ALT. APPLICATION NO. 340 1930

LOCATION 421 East 9th St

Alteration APPLICATION No. 340 193
(N. B., ALT., ELEV., ETC.)

DISAPPROVED ~~February~~ March 1 19³⁰

PLOT DIAGRAM

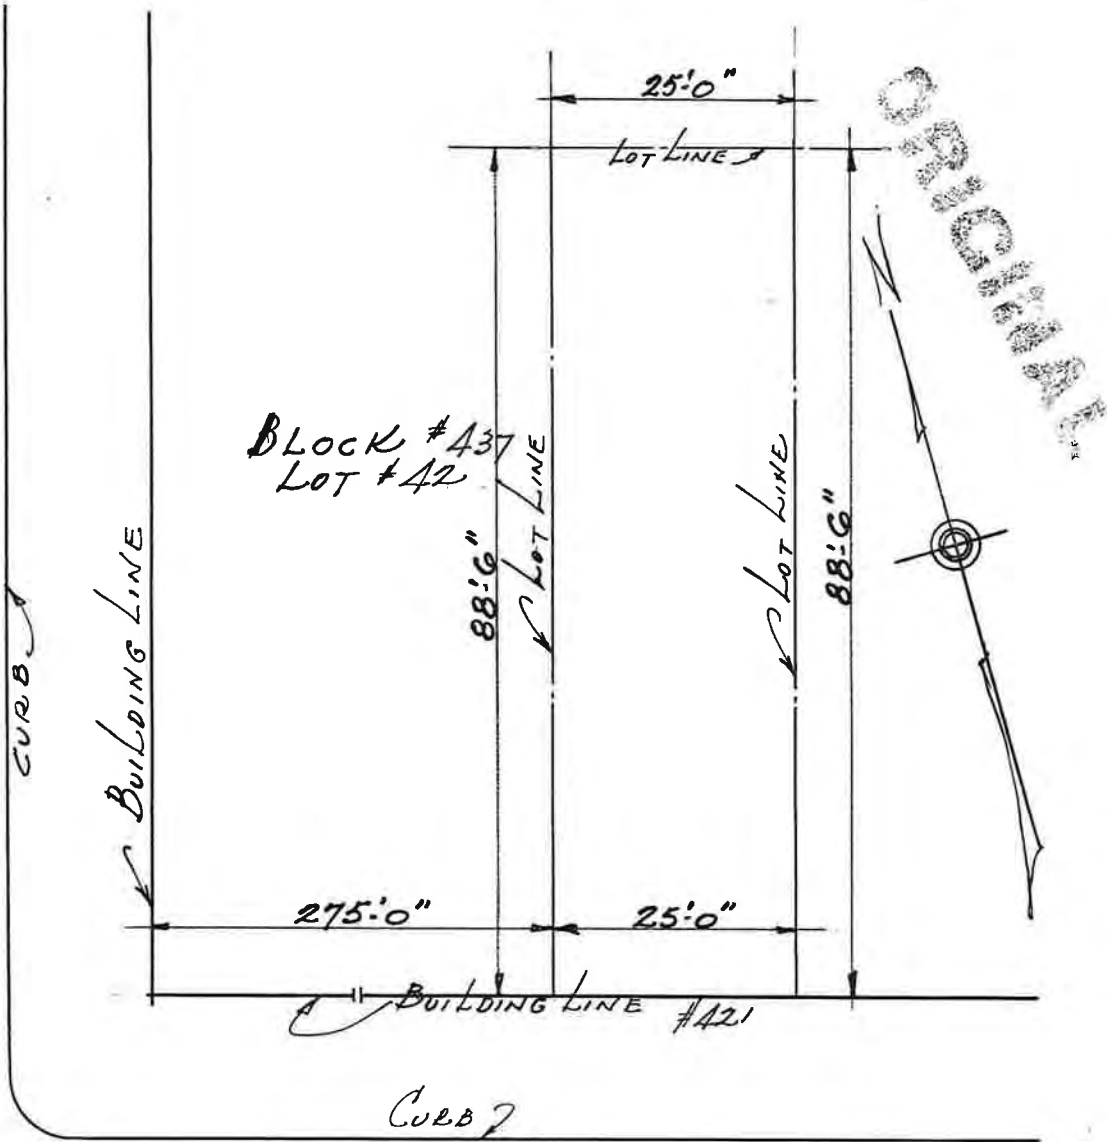
with the following OBJECTIONS:

- 1 Obtain and file approval of Tenement House Department.
- 2 Underpin front wall under columns.
- 3 Show method of bracing front columns.

- 1 - Tenement House Department approval filed herewith.
- 2 - Front wall under column underpinned.
- 3 - Front column braced by strap anchors to wood floor joist.
- 4 - Certificate of occupancy will be obtained.
